CORRIGENDUM - 13 TO NIT NO-63119

Subject: Corrigendum-13 to Tender enquiry for Pre-bid Tie up for Supply & Services of 220kV GIS for IOCL PANIPAT (P25) PROJECT.

TECHNICAL CORRIGENDUM - 1**Dated 18 April 2022****220kV KV GAS INSULATED SWITCHGEAR for IOCL, Panipat**

TECHNICAL AMENDMENT NO: 01 (ELECTRICAL)
TO
TENDER: B269-999-16-50-EB-T-0020 FOR 220KV GIS PACKAGE
(PROJECT: P-25, M/s IOCL-PANIPAT)

DRAWING NO.	REV.
B269-999-16-50-DS-0052	C

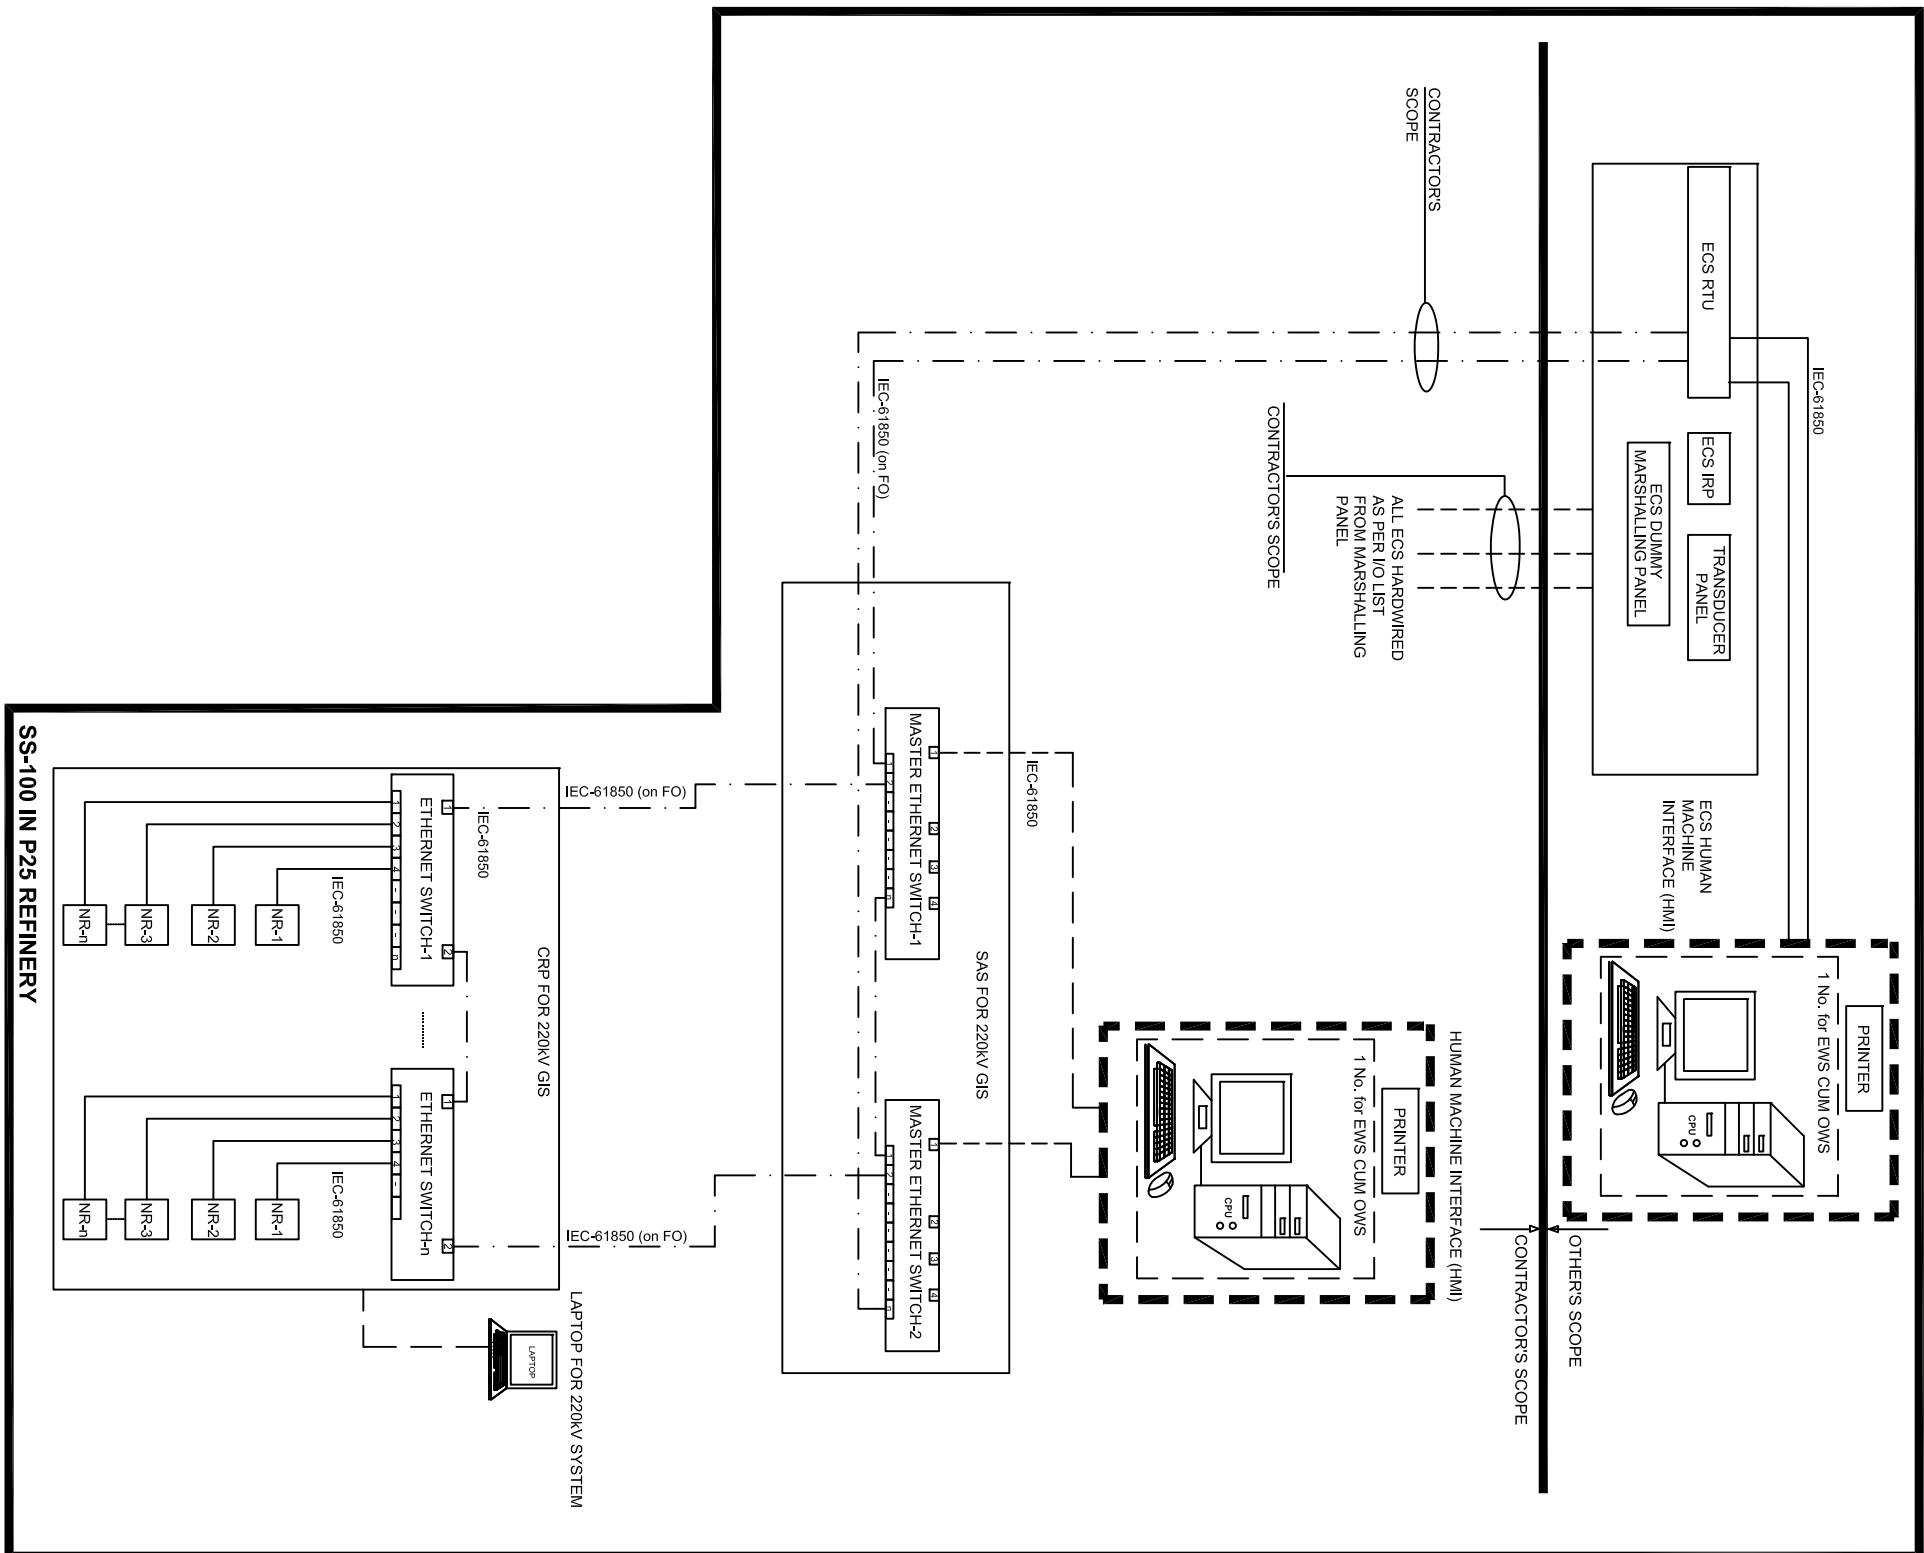
5.	B269-999-16-50-DS-0052 Rev.B	Complete Document	Relay & SAS System Architecture for 220kV GIS	Modification: Data sheet (B269-999-16-50-DS-0052 Rev.B) has been replaced by B269-999-16-50-DS-0052 Rev.C. Copy enclosed herewith.

DRAWING NO.	REV.
B269-999-16-50-DS-0130	C

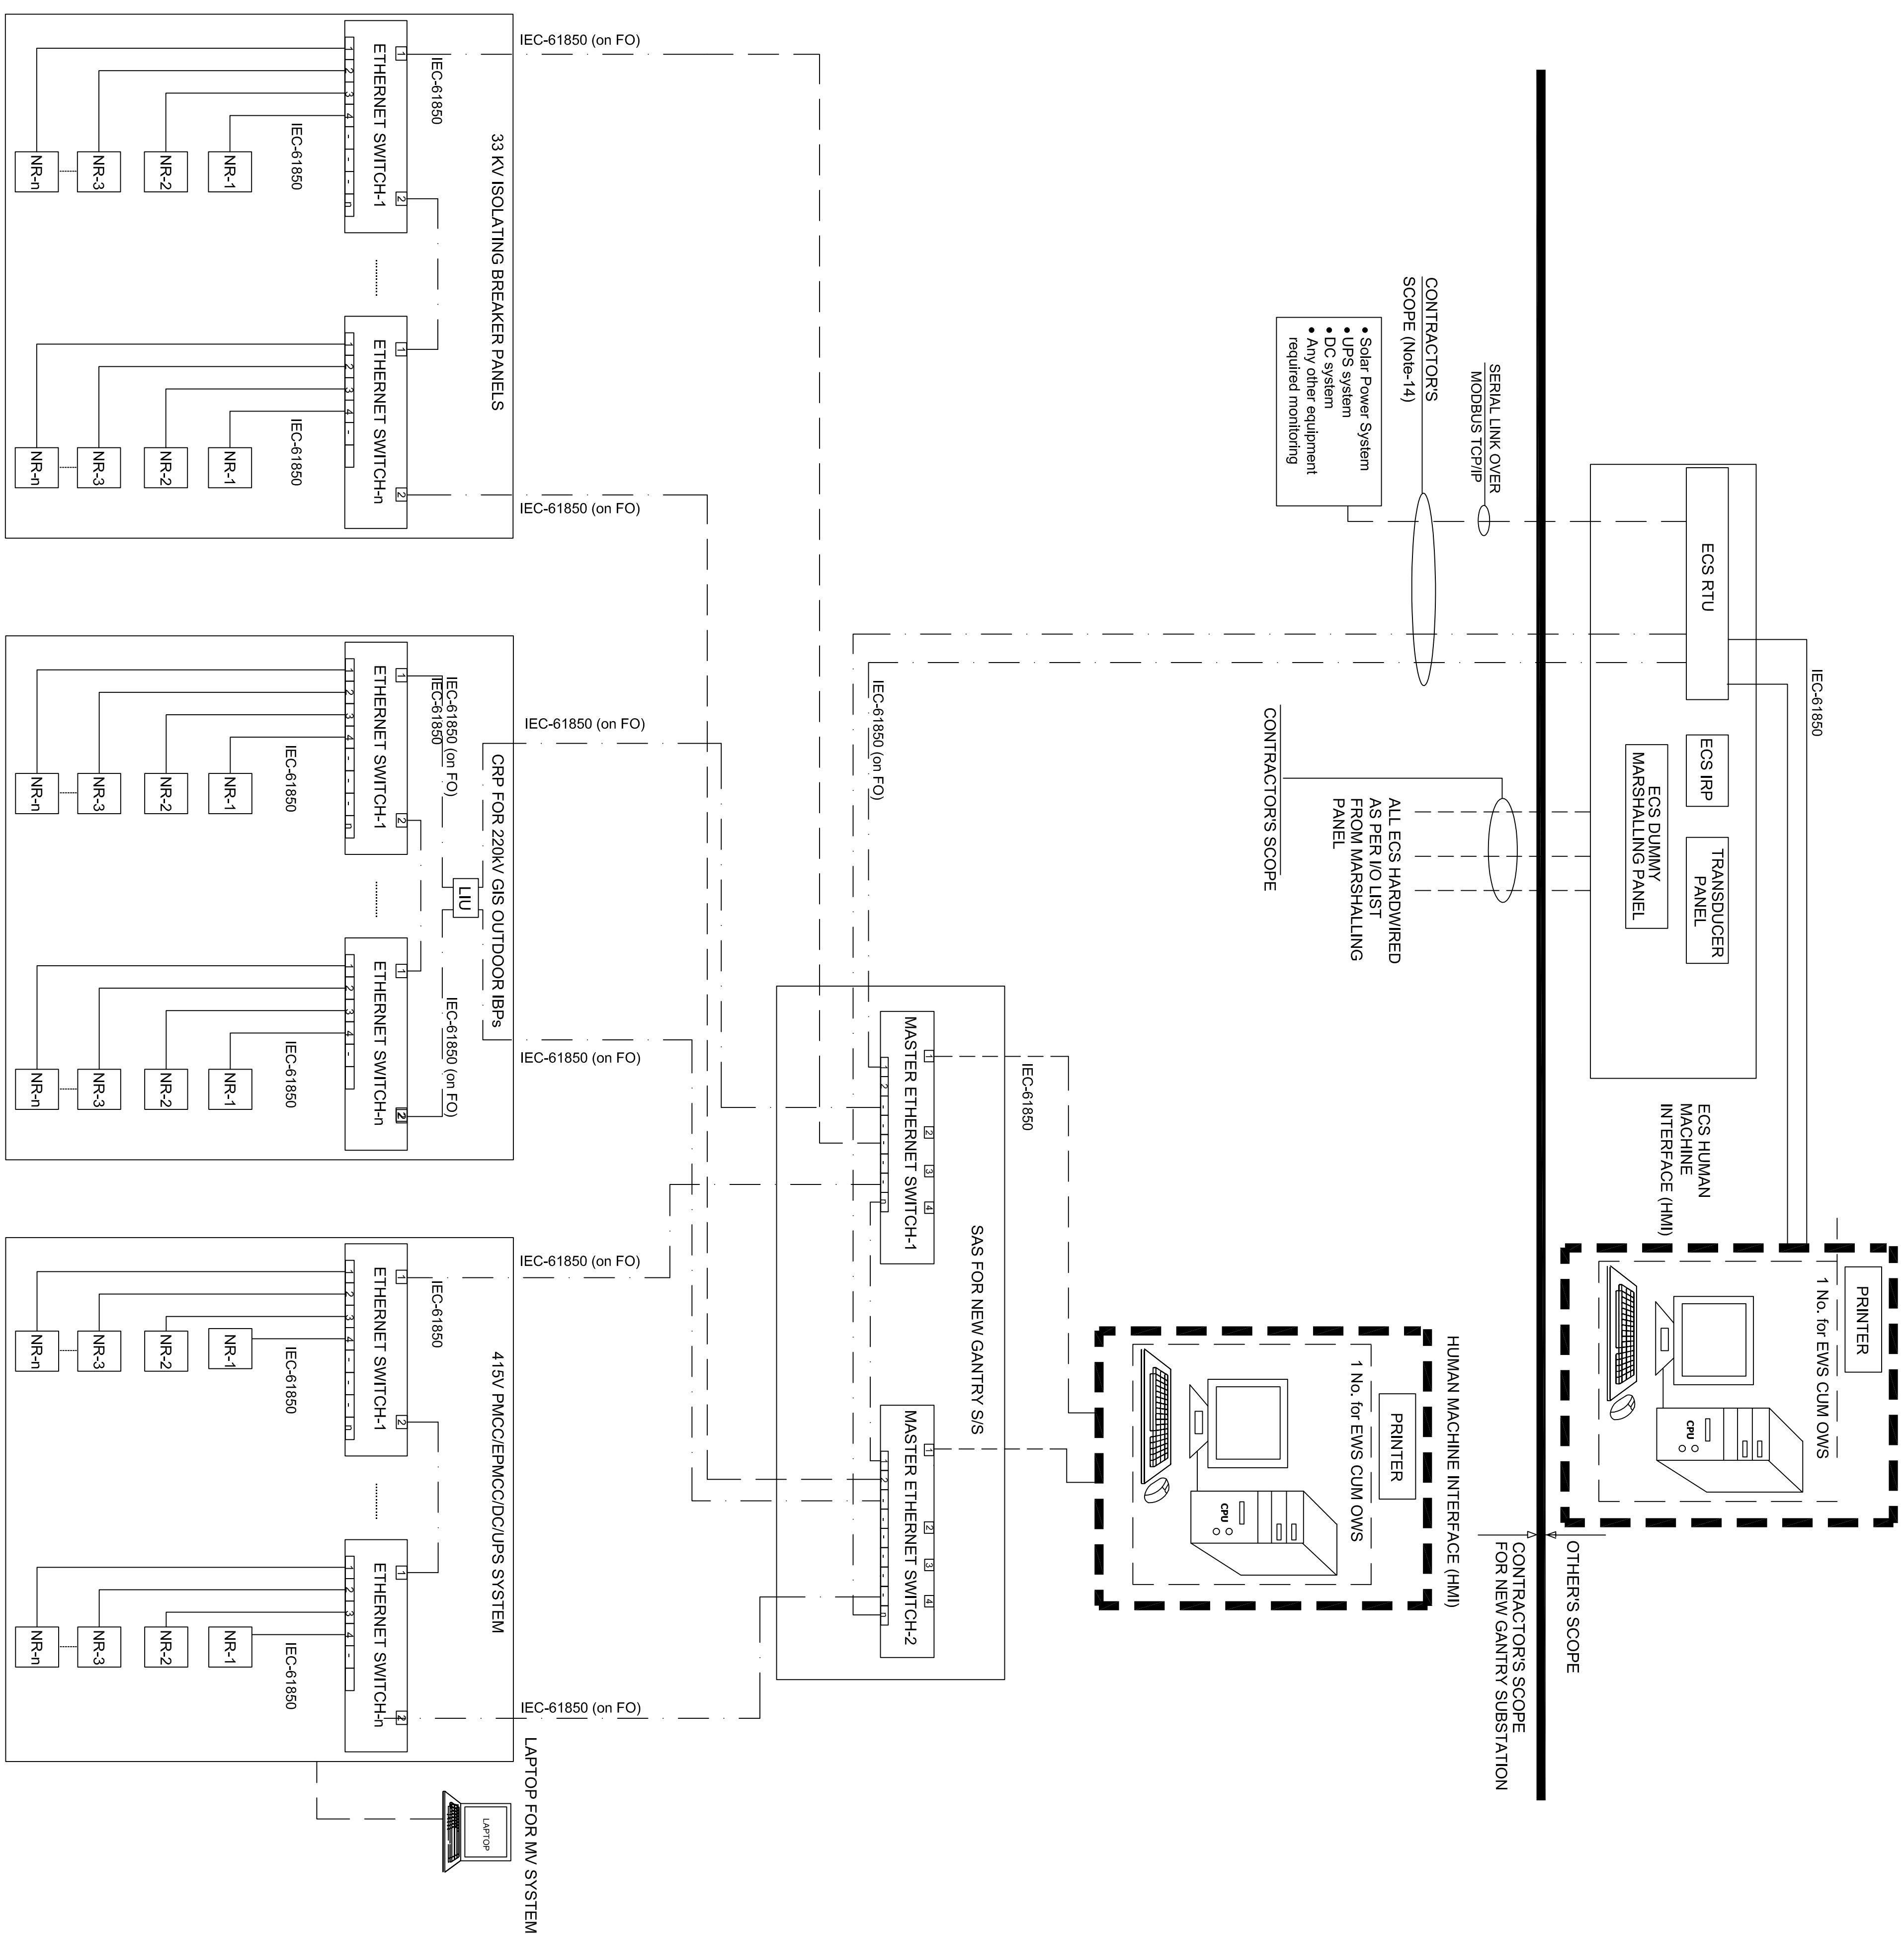
7.	B269-999-16-50-DS-0130 Rev.B	Complete Document	System Architecture for IBPs & MV Switchboard	Modification: Data sheet (B269-999-16-50-DS-0130 Rev.B) has been replaced by B269-999-16-50-DS-0130 Rev.C. Copy enclosed herewith.
